SUBJECT: TECHNICAL REVIEW: GROUNDWATER MONITORING AT AND
NEAR THE PLANNED SALTSTONE DISPOSAL FACILITY
(DOCKET NO. PROJ0734)

Technical Review: Groundwater Monitoring at and Near the Planned Saltstone Disposal Facility

Figure 5: Approximate Extent of the Tc-99 Groundwater Plume and Contours of the Top of TCCZ in Z Area (from SRNS-RP-2015-00902)

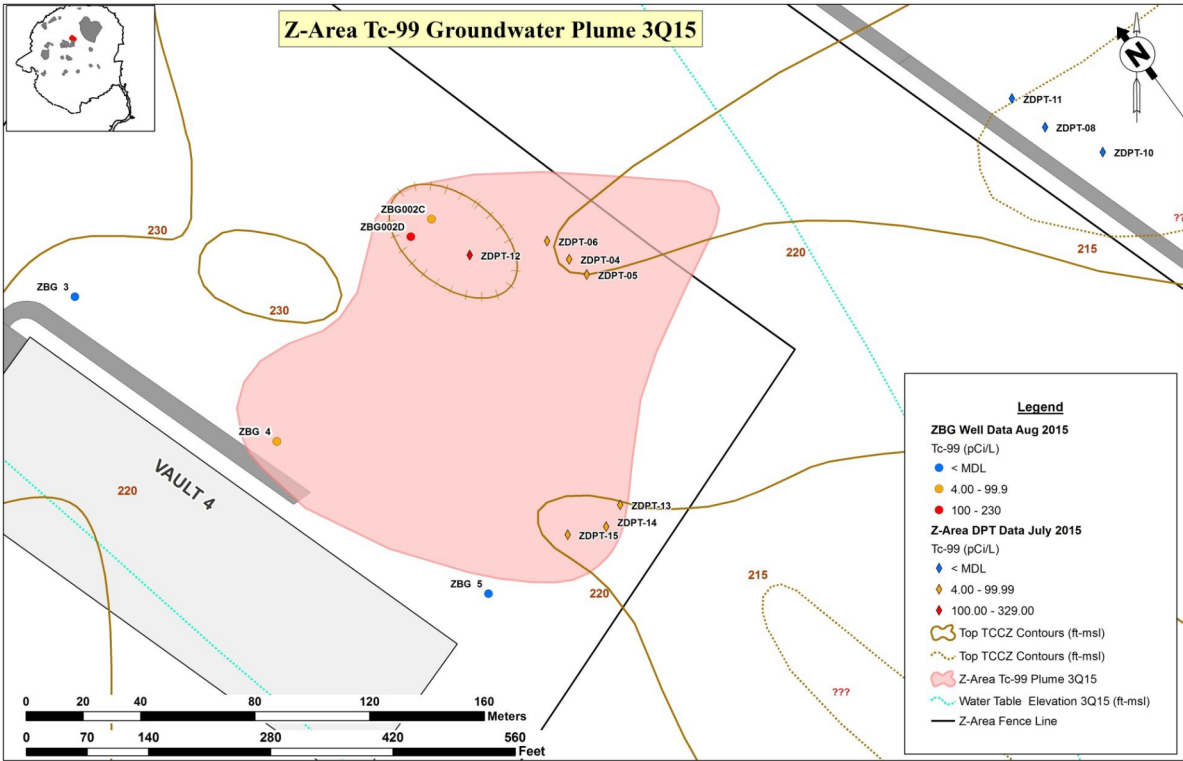
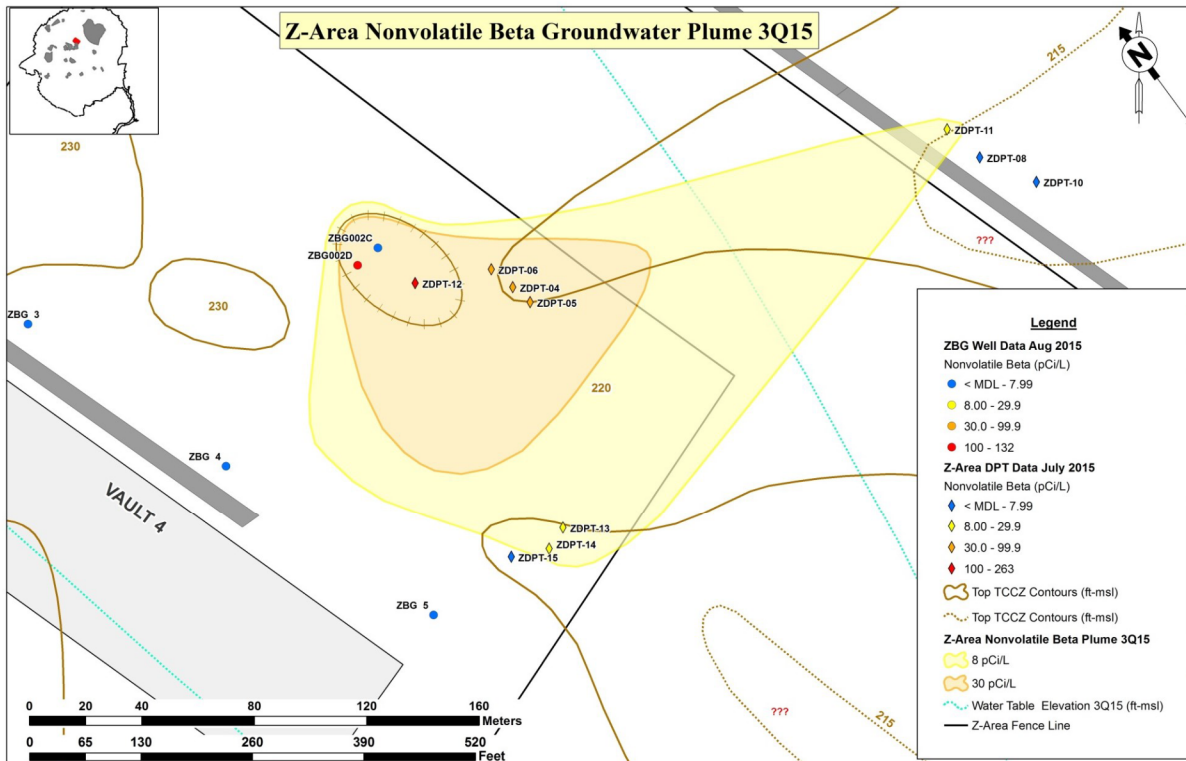
Since 2012, groundwater data has shown an increase in concentration of radionuclides in Well ZBG 2 as discussed in the previous section 'Summary of Current Groundwater Monitoring Results.' Although the elevated nonvolatile gross beta analysis for Well ZBG 2 was originally attributed to naturally-occurring radionuclides (SRNS-TR-2012-00285; Page 5), higher measurements the following years made plain that it could not be solely attributed to naturally-occurring radionuclides. In March of 2013, the nonvolatile gross beta had already exceeded 30 pCi/L at ZBG 2 with sampling result of 68.0 pCi/L. The DOE 2010 Groundwater Monitoring Plan (WRSC-TR-2005-00257, Rev.5) stipulates data reporting and actions in case of sample results exceeding the GWPS. This plan states that, "If the follow-up sampling confirms results above 30 pCi/L for gross beta, a plan for assessing the lateral and vertical extent of the plume will be developed and submitted to SCDHEC within 60 days," and also, "If a GWPS is exceeded, this will be reported to SCDHEC promptly, and the well will be resampled within 30 days. If the exceedance is confirmed, all wells will be sampled for the complete GWPS list (Table 1), and an assessment monitoring plan will be submitted." Subsequently, additional sampling and a resulting Z Area groundwater characterization study documented (SRNS-RP-2015-00902) a plume (see Figures 5 and 6 in this report).

The results of the 2015 Z Area groundwater characterization study provided convincing evidence that the plume has traveled past the boundaries of the Z Area (especially the results of ZDPT 10 and ZDPT 11), and that horizontal transport is much more dominant than vertical

Figure 7: 2017 Nonvolatile Gross Beta Groundwater Plume from Figure 8 in SRNS-TR-2017-00387 Shown as Dashed Orange Line

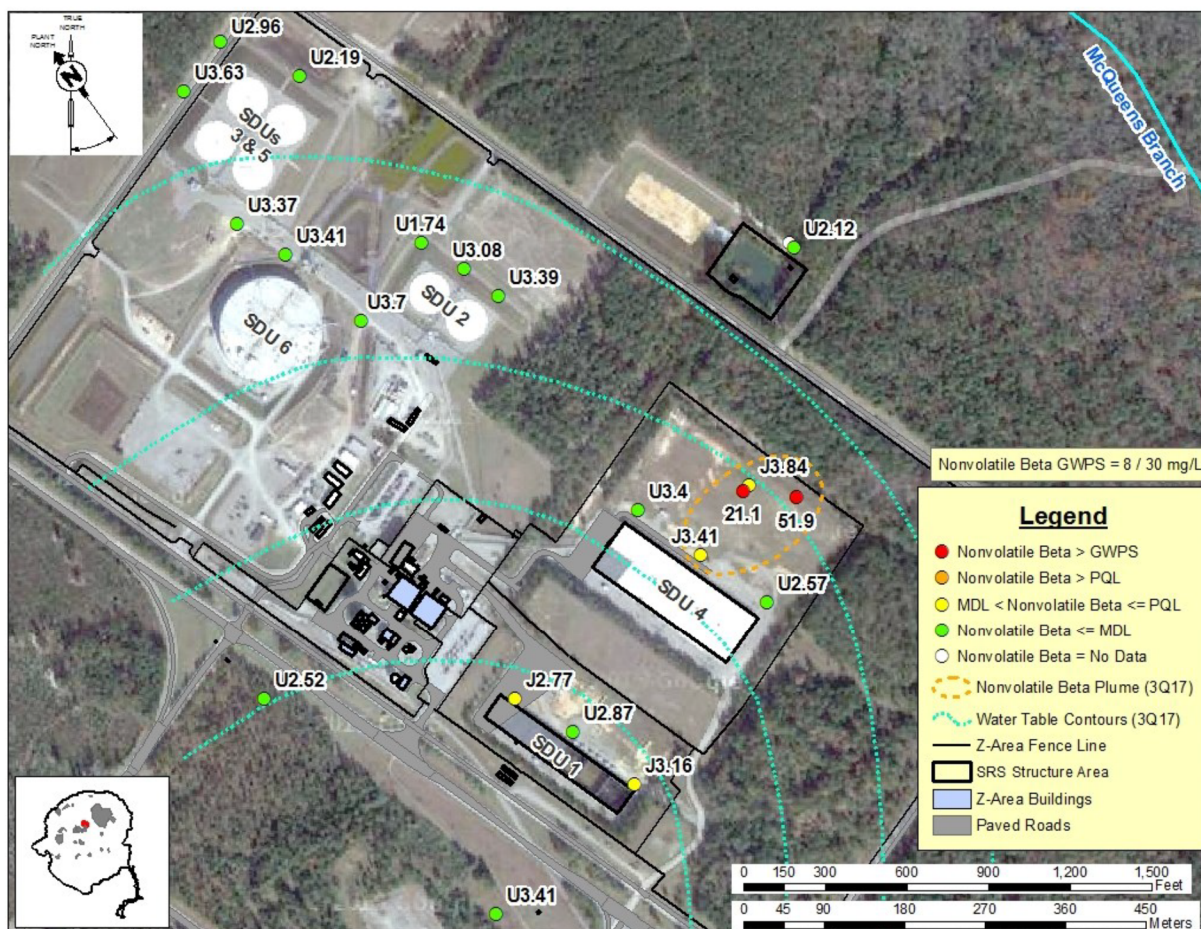
The Z Area groundwater report from 2016 and 2017 (SRNS-TR-2016-00312 and SRNS-TR-2017-00387, respectively) no longer include the results from the 2015 Z Area groundwater characterization study when showing the extent of the plume (see Figure 7 below). Figures 8 and 9 in the 2017 Z Area Groundwater Report show a dashed line representing the extent of the nonvolatile gross beta plume and Tc-99 plume, respectively. Both plumes are considerably smaller than the plumes showed in the 2015 Z Area Groundwater Report (i.e., Figure 6 for nonvolatile gross beta and Figure 8 for Tc-99 in SRNS-TR-2015-00300). The representations of

the 2016 and 2017 plumes have been shortened to the east and the south. The DOE gave no explanation for these changes. No UTRA-UAZ data on nonvolatile gross beta and Tc-99 exists which would allow a delineation of the plumes' boundaries to the north.

Figure 7 from the 2017 Z Area Groundwater Report shows peak concentration values for Well ZBG 2 and Well ZBG 2D having occurred back in 2015. As suggested by the DOE, this may indicate that the peak of the plume has moved on. The NRC staff is interested in knowing where the peak of the plume is currently and in what direction it is heading because that knowledge would both provide information on flow and radionuclide transport in the Z Area and allow a better evaluation of the potential safety concerns emanating from the plume. New DPT samples and/or new monitoring wells would be required to follow the peak of the plume.

Figure 8(a)-(d): UTRA-UAZ Water Thickness (ft) for the Years 2003 to 2017 (Data from Z Area Groundwater Monitoring Reports from 2003 through 2017)

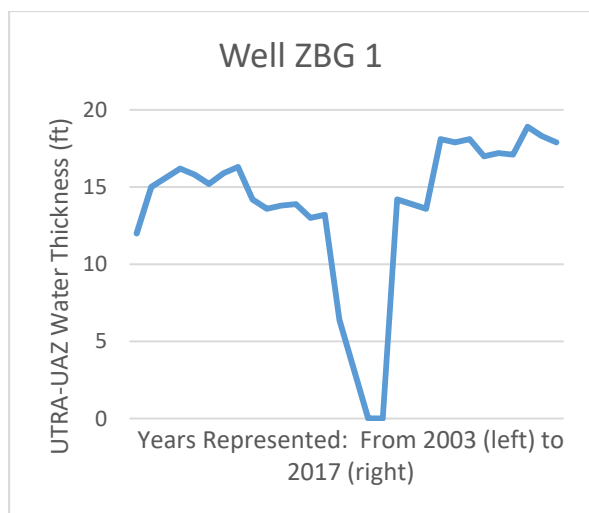
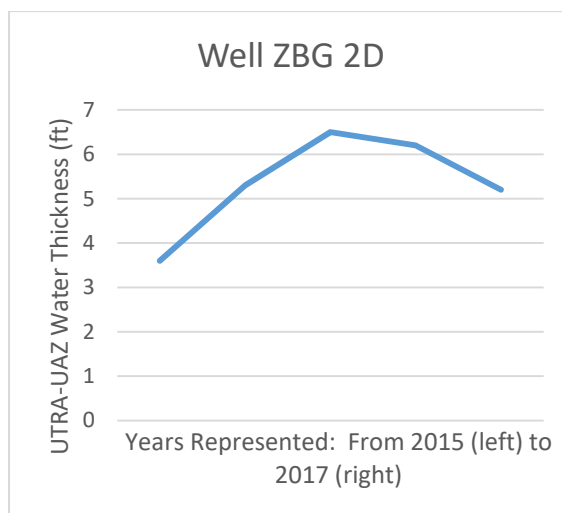
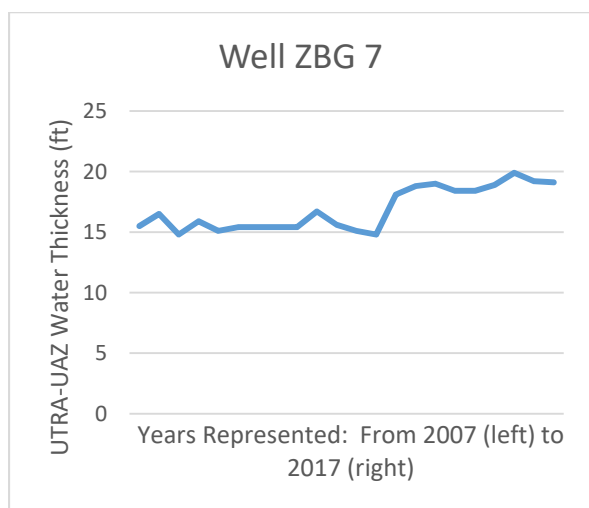
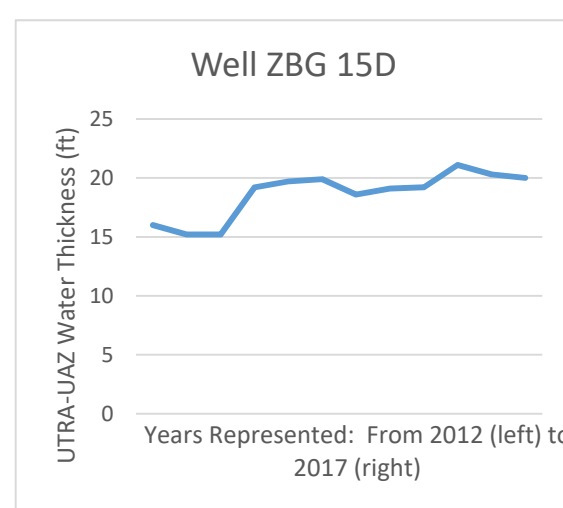
It is possible that it would not be cost effective to install a groundwater monitoring well in both the UTRA-UAZ and the UTRA-LAZ if the UTRA-UAZ is dry near the locations of interest. However, the data that have been collected up to this point indicate that the UTRA-UAZ is saturated for most of the time at many locations. Figure FFT-1.3 from SRR-CWDA-2016-00004 shows the water levels in ZBG 2. Between 1987 and 2014, a total of nine samples were taken when water levels within ZBG 2 were below that of the top of TCCZ coinciding with two periods of relatively low rainfall and indicating that the UTRA-UAZ was dry. However, for the rest of that time period the UTRA-UAZ contained water. Figures 8(a) through (d) also show water thicknesses within the UTRA-UAZ for ZBG 1, ZBG 2D, ZBG 7, and ZBG 15D. Only the background well ZBG 1 had one year (2011) in which the UTRA-UAZ was dry, and the data for 2010 is missing with regard to Well ZBG 7 which is representative of the area near SDS 1. Wells ZBG 6 and ZBG 8 had similar UTRA-UAZ water thicknesses as in Well ZBG 7.
